UNITED STATES PATENT AND TRADEMARK OFFICE

APPLICATION NO.	FILING DATE	FIRST NAMED INVENTOR	ATTORNEY DOCKET NO.	CONFIRMATION NO.
10/777,950	02/12/2004	Tommy Rodrigues	FDN-2797	7092
Attn: William J. Davis, Esq. GAF MATERIALS CORPORATION Legal Department, Building No. 10 1361 Alps Road Wayne, NJ 07470			EXAMINER GILBERT, WILLIAM V	
			ART UNIT 3635	PAPER NUMBER
			MAIL DATE 12/23/2009	DELIVERY MODE PAPER

Office Action Summary

DETAILED ACTION

Figure 5 from Bondoc

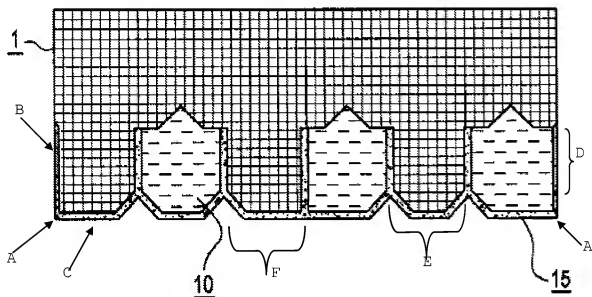
Regarding Claims 8 and 29, Bondoc discloses a shingle with at least one layer (per Claim 29), a posterior layer (15) with a head lap (element "B" from attached Figure 5 from Bondoc, above) and tabs (element "C" from attached Figure 5 from Bondoc, above), an anterior layer positioned on the posterior layer (1), an anterior head lap (Figure 1, element 3), an alignment notch (Figure 1, element 6) and at least one anterior tab (Figure 1,

Regarding Claim 16, the posterior tabs (element C above) extend beyond the anterior tab (2; see Bondoc: Figure 5, generally).

Regarding Claims 17, 19 and 21 the anterior head lap (Bondoc: Figure 9, area proximate element 40, per Claims 17, 19, 21) extends beyond the posterior head lap (Figure 9, area proximate element 44, per Claim 17) the anterior head lap edge aligns to a posterior head lap edge (Figure 9, element 48, see area proximate element 42 where dotted line represents how the two headlaps may align, per Claim 19) and the posterior head lap extends beyond the anterior head lap (element "D" from attached Figure 5 from Bondoc, above, where the posterior head lap extends beyond the anterior headlap, per Claim 21).

Regarding Claim 25, the anterior tab (2) has a corner that corresponds to the alignment notch (see area proximate element A from attached Figure 5 above).

Regarding Claim 26, the posterior tabs (element "C" from attached Figure 5 from Bondoc, above) have corners (area proximate "A" above) that correspond to the alignment notch (6).

Regarding Claim 27, the anterior tab is positioned substantially centered on the posterior tab (element "E" from attached Figure 5 from Bondoc, above).

Regarding Claim 28, the anterior tab is positioned offset from the posterior tab (element "F" from attached Figure 5 from Bondoc, above).
